<b>Subject:</b> SQUEAK AND/OR RATTLE NOISE FROM FRONT SEAT BELT BUCKLE	<b>Bulletin No:</b> 08-003/09
	<b>Last Issued:</b> 05/22/2009

- This bulletin supersedes the previous bulletin 08-003/09 issued on 05/15/09. The WARRANTY INFORMATION has been revised.
- Changes are noted below in Red beside the change bar.

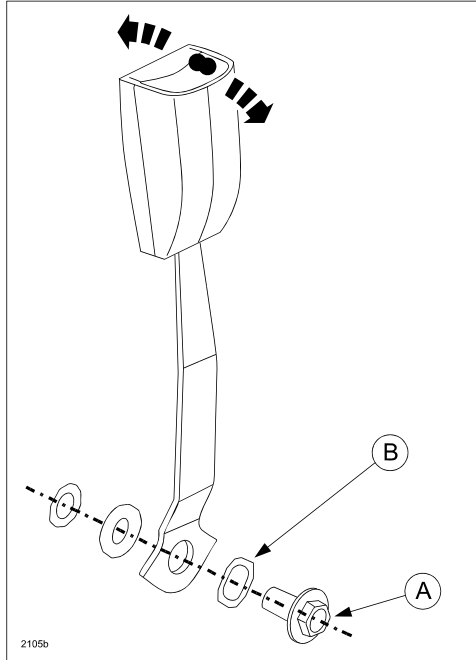
A squeak and/or rattle noise may come from the driver side seat while driving on slightly uneven road surfaces. Due to assembly variation, the bolt and washer may come in contact with each other causing the noise.

The diameter of the bolt flange has been increased during mass-production.

1. Verify the customer concern by moving the buckle left and right.
  - If the noise is heard, replace the bolt (A) with a new one.  
**Tightening Torque: 28.2 - 57.8 ft. lbf. (38.2 - 78.4 Nm, 3.9 - 7.99 kgf.-m)**
  - If the noise is not heard, refer to the Workshop Manual for further diagnostics.

**NOTE:** Ensure wave washer (B) is installed.

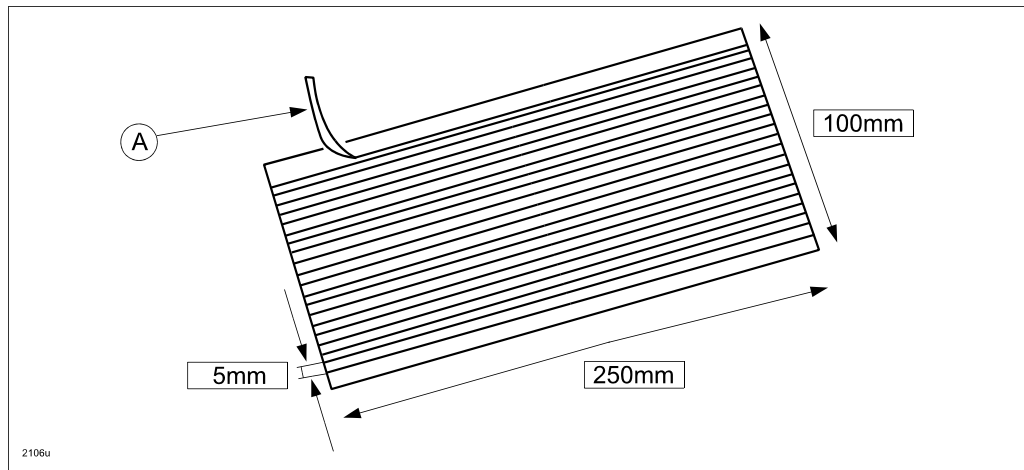
If an urgent repair is necessary and the bolt is not available, repair using the following procedure.

1. From Noise Repair Kit, peel off a 5mm strip pad (A).

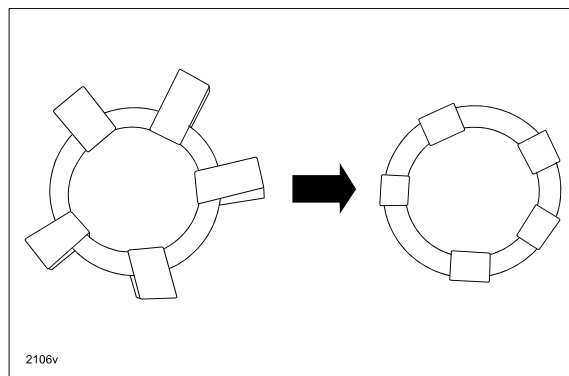
2. Wrap strip pads around wave washer (B) at five (5) locations; cut off any surplus.

3. Reinstall removed parts.

- Do not apply any grease.
- Ensure the buckle can move properly.
